## CCPS RFP#25-04 – NORTH EAST MIDDLE/HIGH SCHOOL REPLACEMENT PROJECT

### ADDENDUM #7

**This addendum is to provide the pre-bid agenda and attendance list and issued revisions to the contract documents as noted below.** Proposers and related parties will be responsible for reading and understanding all documents, the scope of work, addenda and all related solicitation documents issued. These documents will become attached to and part of the solicitation and award of bid contract.

1. **ASIs 01 and 02**
2. **PR 01**
3. **CLOSED RFIs 001- 0027, 029-031, 034. (open RFIs are excluded)**

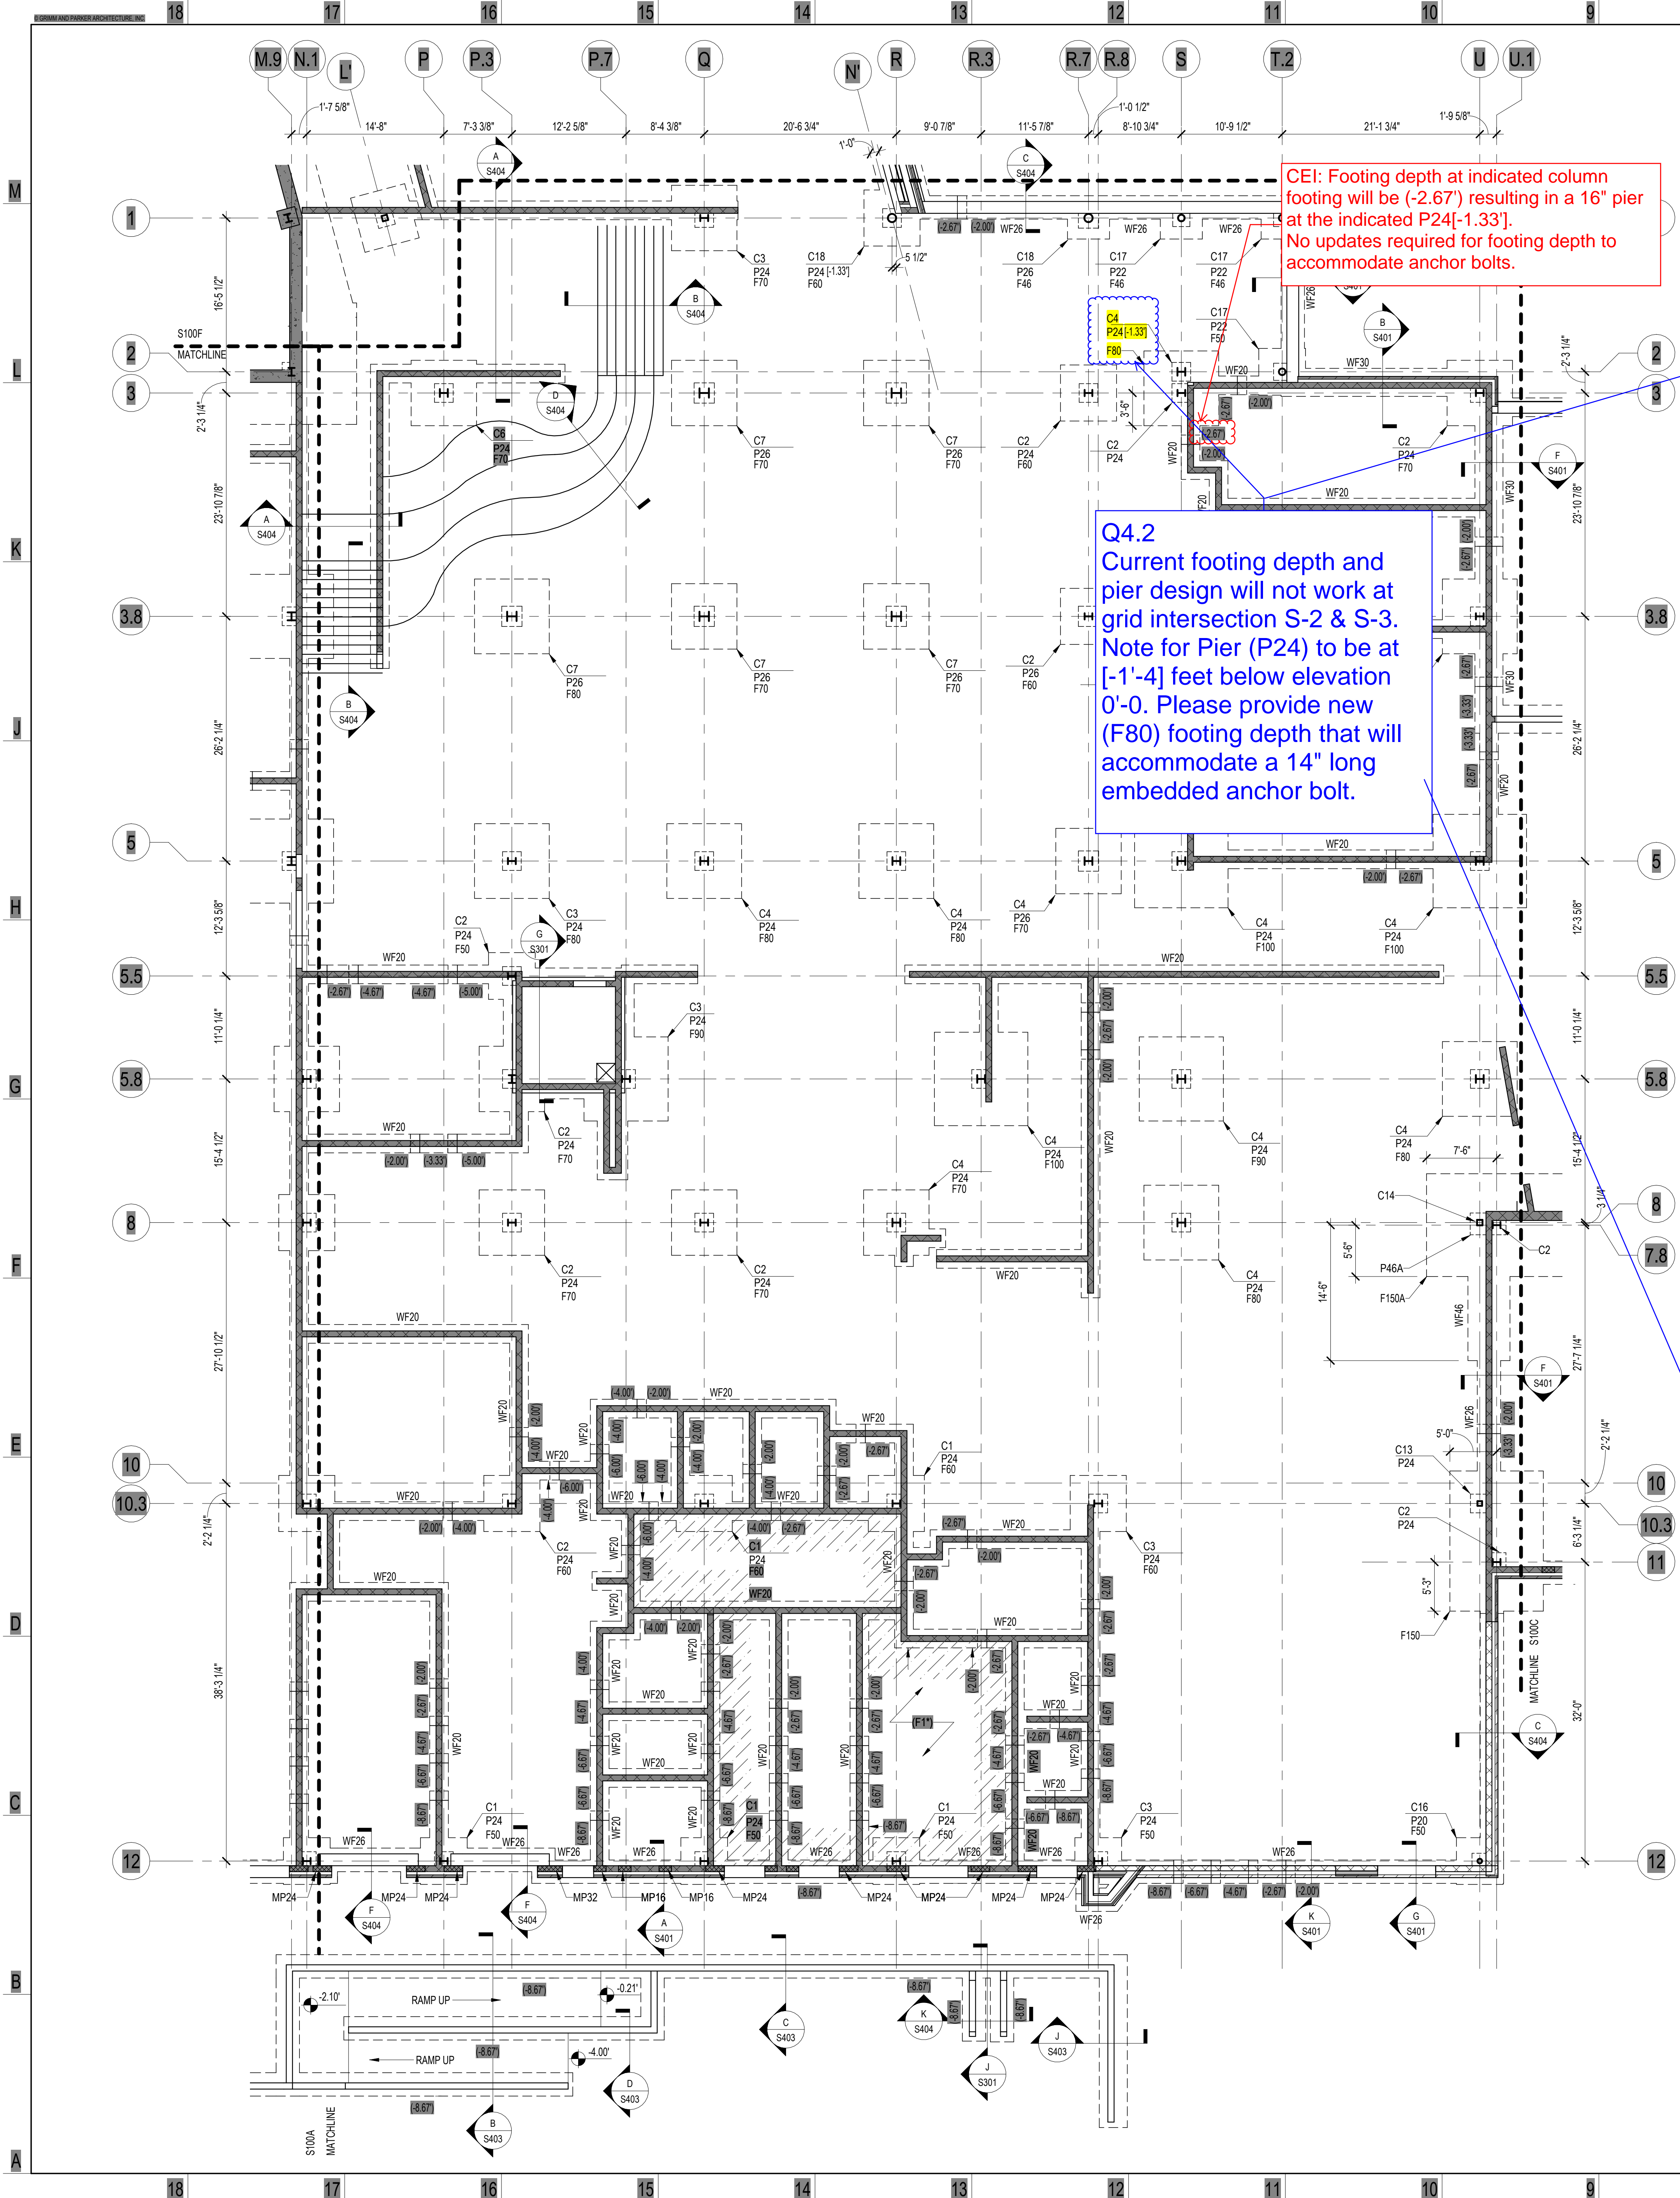
CEI: Footing depth at indicated column footing will be (-2.67') resulting in a 16" pier at the indicated P24[-1.33'].  
No updates required for footing depth to accommodate anchor bolts.

PENTHOUSE ROOF FRAMING PLAN - AREA G

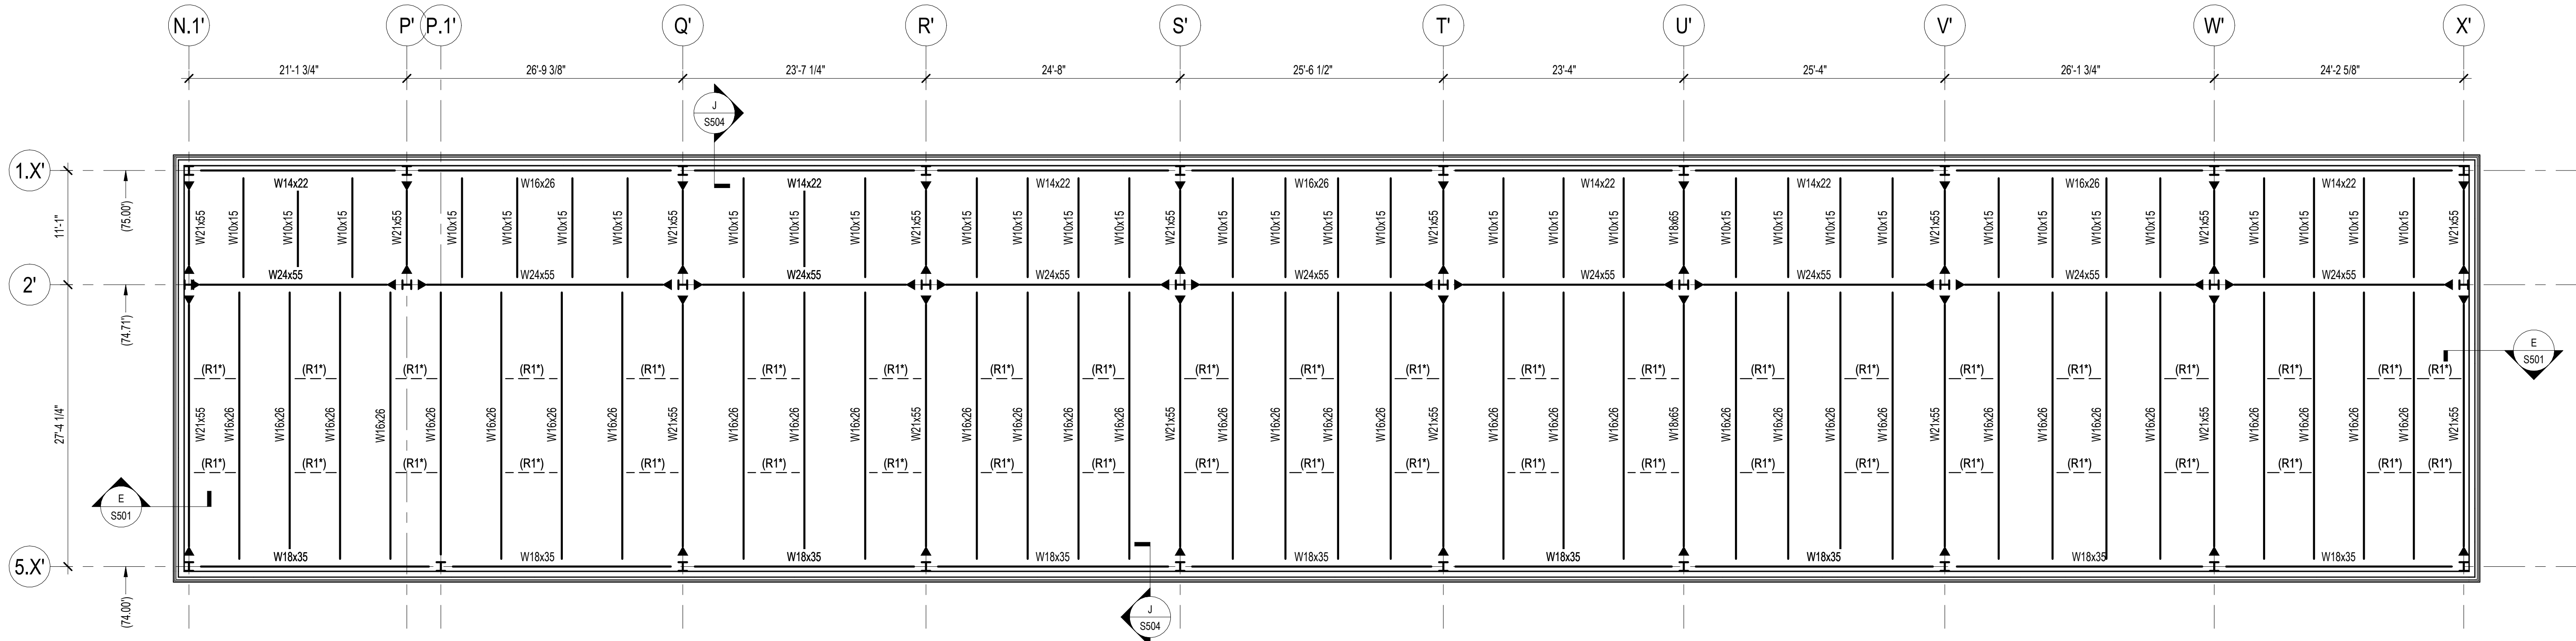
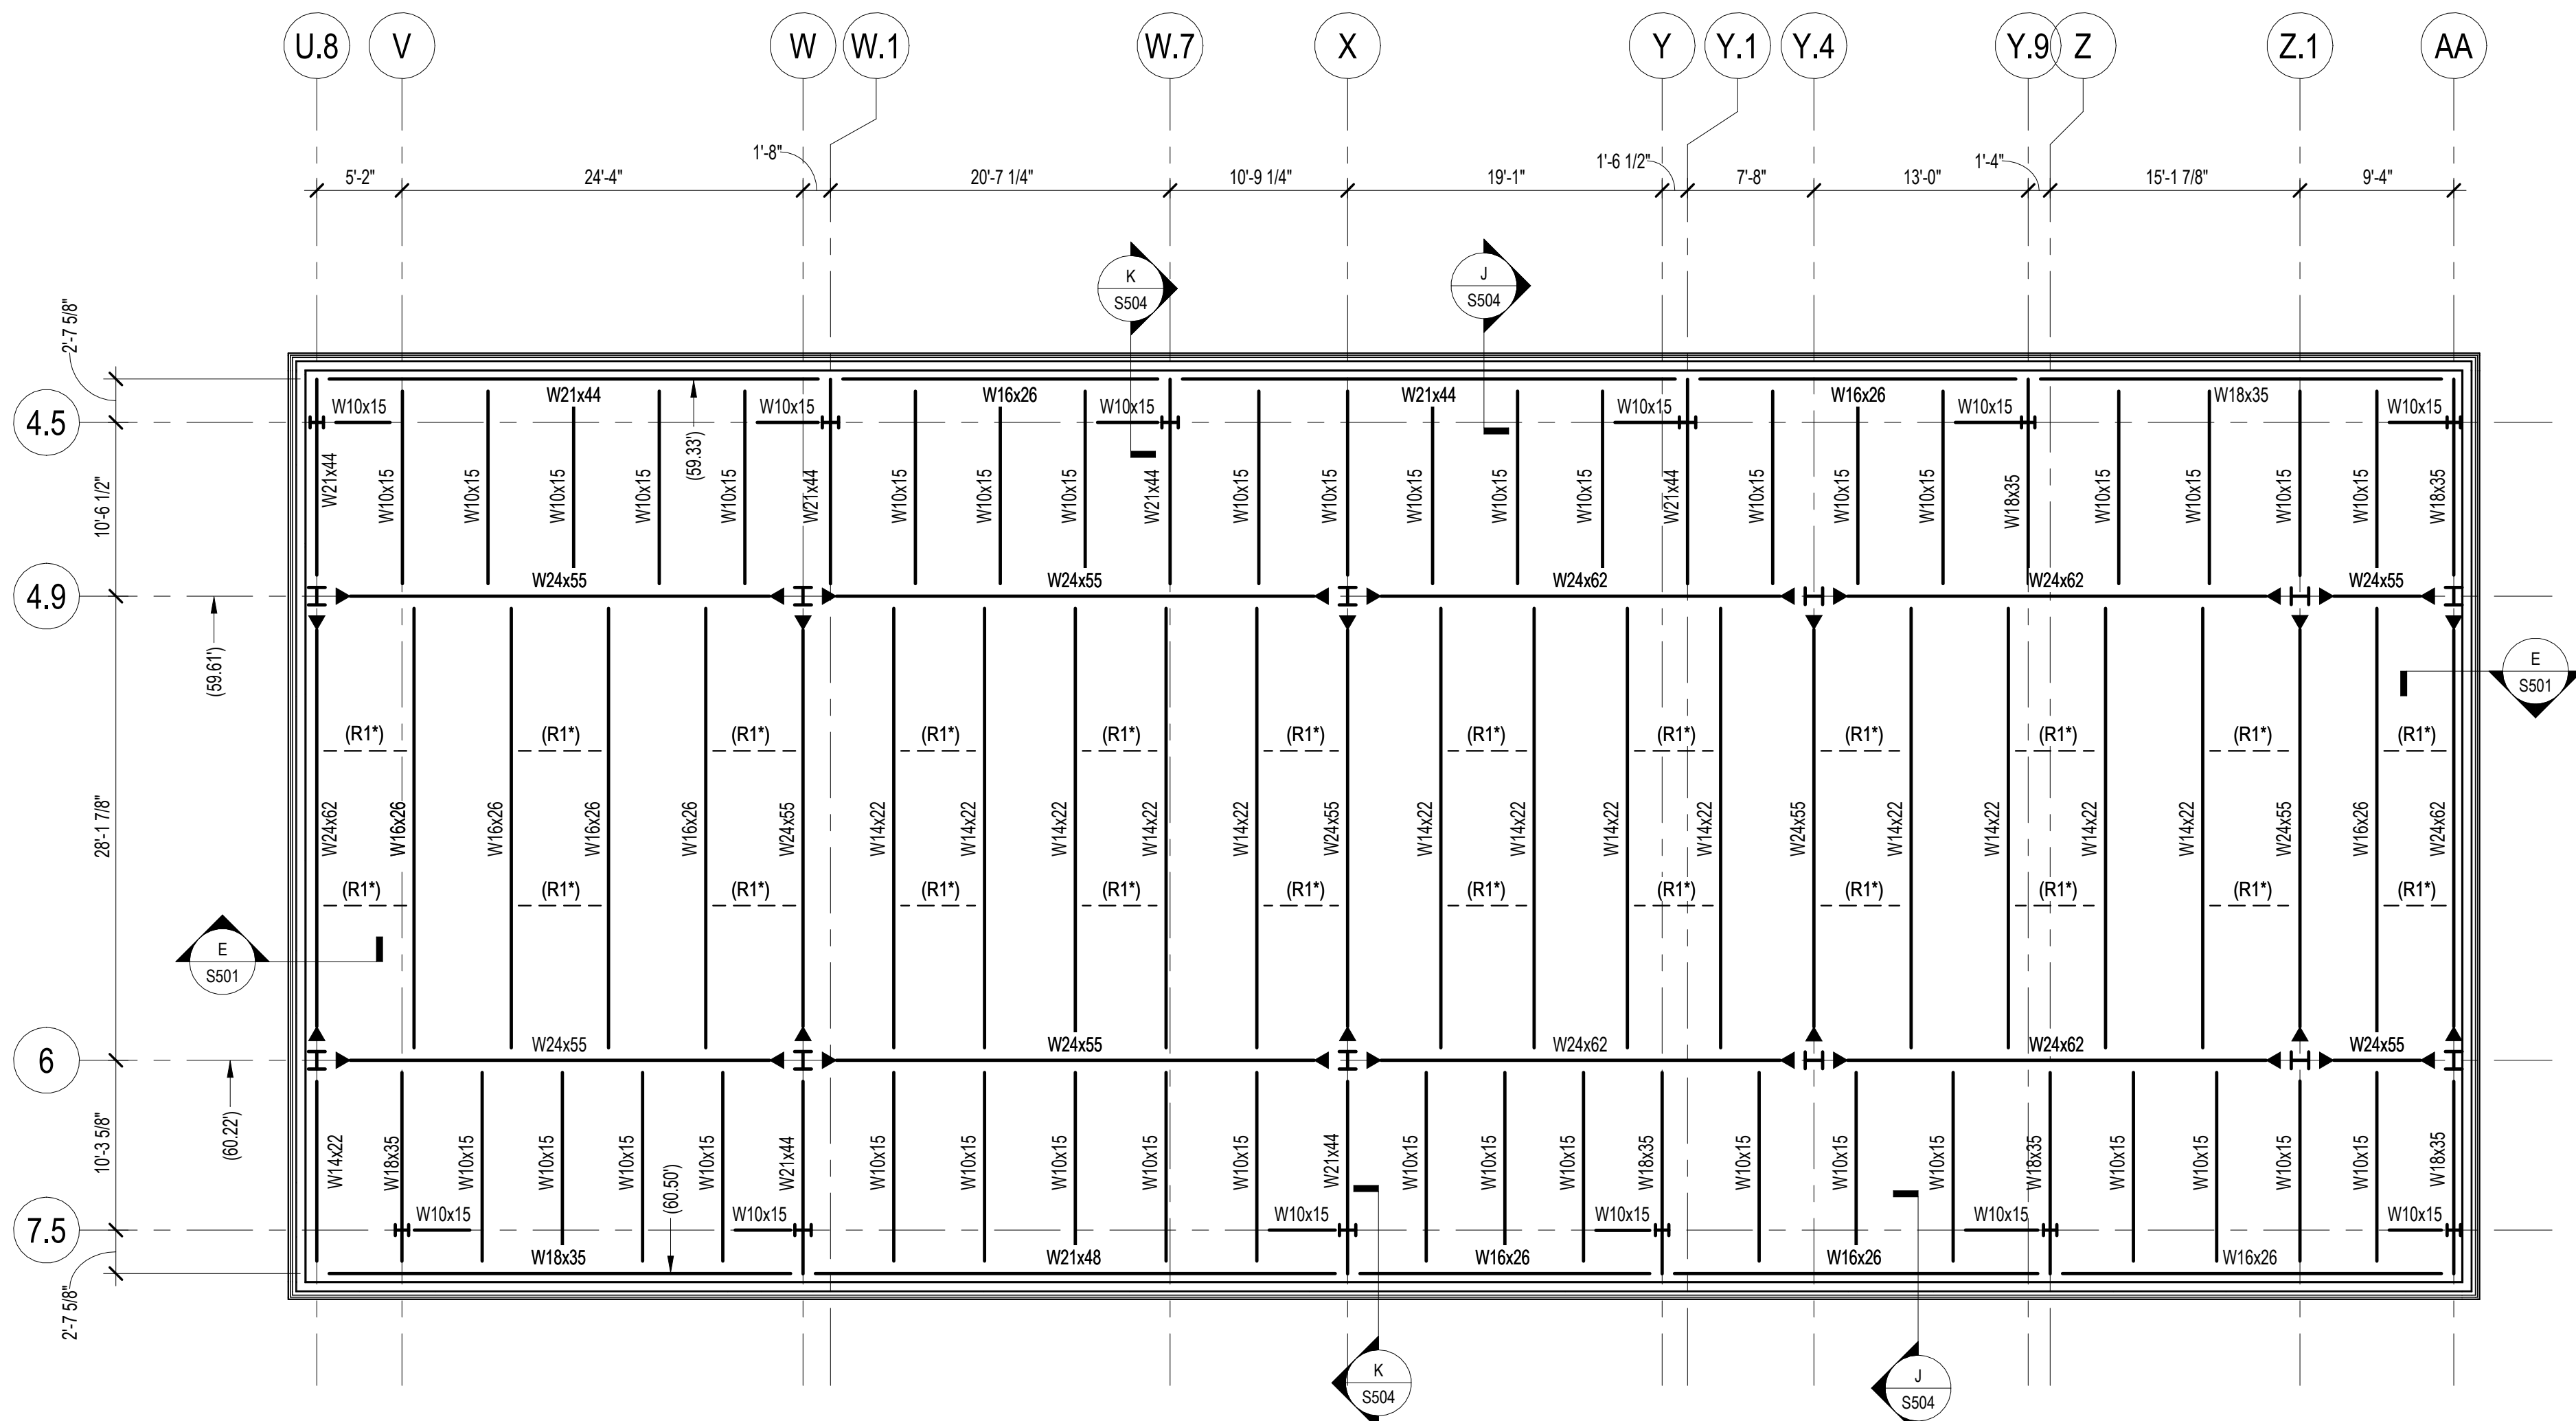
1. On S105, please confirm if (R1\*) roof frames are to be bolted or welded to the attached beams to ensure accuracy with detailing.
